Item 5.**Development Application: 650 Botany Road, Alexandria - D/2022/165****File No.:** D/2022/165**Summary****Date of Submission:** 1 March 2022**Applicant/ Architect:** Orosi Architecture**Owner:** Donebo Pty Ltd**Planning Consultant:** Planning Ingenuity**DAPRS:** 7 June 2022**Cost of Works:** \$6,895,462.00**Zoning:** The site is zoned B7 Business Park. The application describes the proposed development as shop top housing, which is permissible in the zone.

Proposal Summary: The application seeks consent for demolition of the existing structures, excavation and construction of a 6 storey 'shop top housing' development including:

Figure 24: Ground floor plan, which shows the commercial tenancy outlined in red

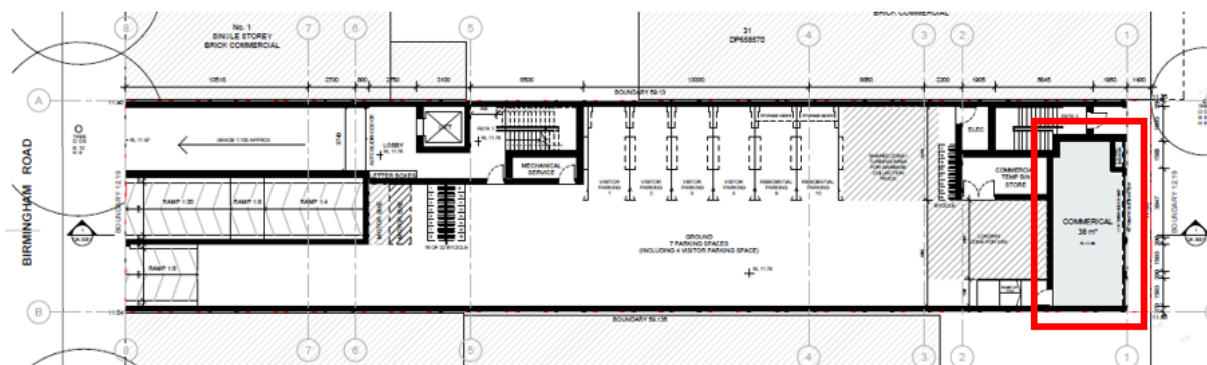
56. The site is located within the B7 Business Zone within the Sydney Local Environmental Plan 2012 (SLEP 2012). While residential accommodation is prohibited in the zone, clause 1AA of Schedule 1 allows for shop top housing development on this site.
57. The SLEP 2012 defines shop top housing as meaning "one or more dwellings located above the ground floor of a building, where at least the ground floor is used for commercial premises or health services facilities."
58. The proposed ground floor includes a small commercial premises fronting Botany Road with a total area of only 38sqm, with associated loading docks and waste storage. The rest of the ground floor comprises residential car parking, vehicle access and the residential lobby (see Figure 24 below).

59. Overall, the proposal has not adequately demonstrated that the proposed development meets the definition of shop top housing. In particular, the building fronting Birmingham Street is located entirely over residential access and car parking and is not considered to meet the definition of shop top housing.
60. The proposal has also not adequately demonstrated that it achieves the objectives of the B7 Business Zone, which seek to provide a range of office and light industrial uses, encourage employment opportunities, enable other land uses that provide facilities or services to meet the day to day needs of workers in the area and to ensure uses support the viability of nearby centres.

Figure 25: Ground floor plan, showing residential access via Birmingham Street

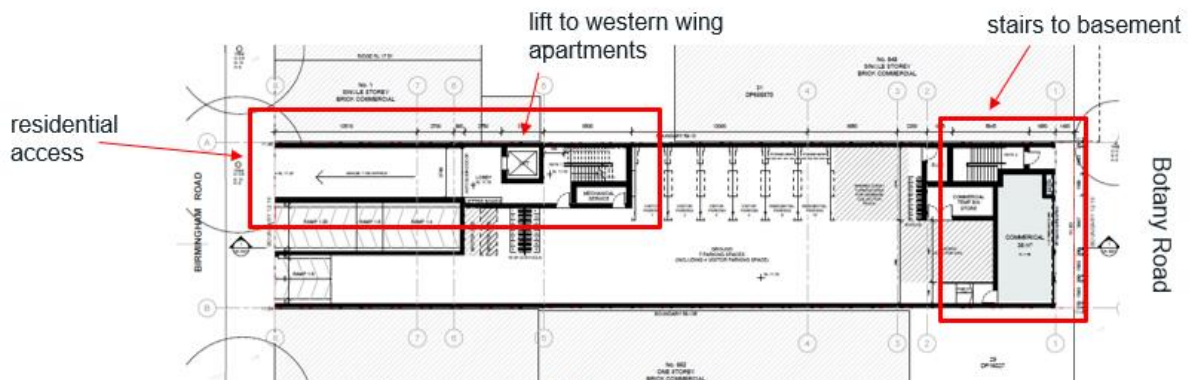
64. The proposed circulation strategy, including vertical circulation, is unacceptable for reasons of amenity and safety and the current design is contrary to fire egress requirements.
65. Access to the residential apartments is via Birmingham Street at the rear of the building. This includes a long pedestrian ramp into the residential lobby at the ground floor and entry via a lift to the western residential wing on level 1 (see Figure 25 below).

Figure 26: First floor plan, showing the route from the lift in the western wing, via the courtyard to the eastern wing

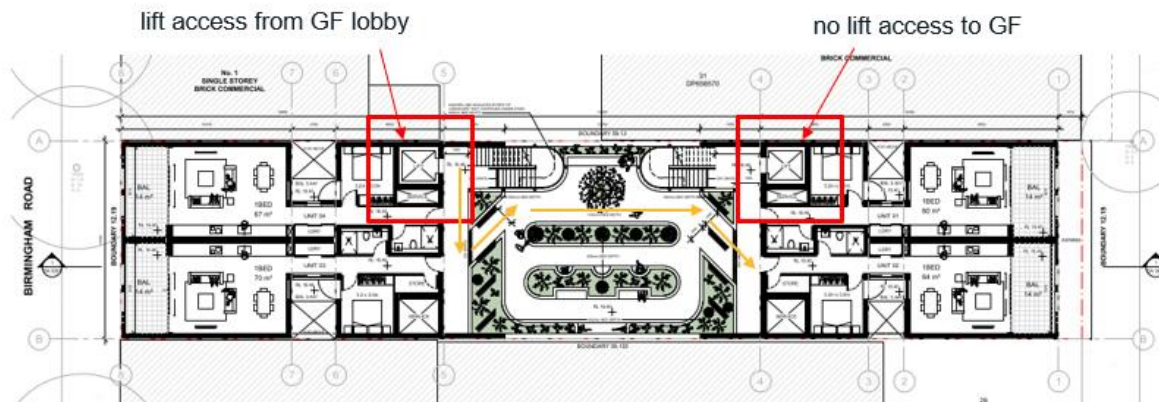
66. From the western residential wing, residents seeking to access the eastern residential wing need to walk through an indirect path in the communal courtyard and then into the eastern wing. From there, no lift access is provided down to the ground floor (see Figure 26 below).

67. The above design does not result in an acceptable level amenity or access for future occupants of the building.
68. In terms of fire egress, this design means that the egress paths include open stairs at a fire source feature, crossing the podium and re-entering the building and passing an active lobby lift prior to discharge. The ability to comply with the requirements of fire egress in a Class 2 building has not been demonstrated and would likely significantly alter the proposal.
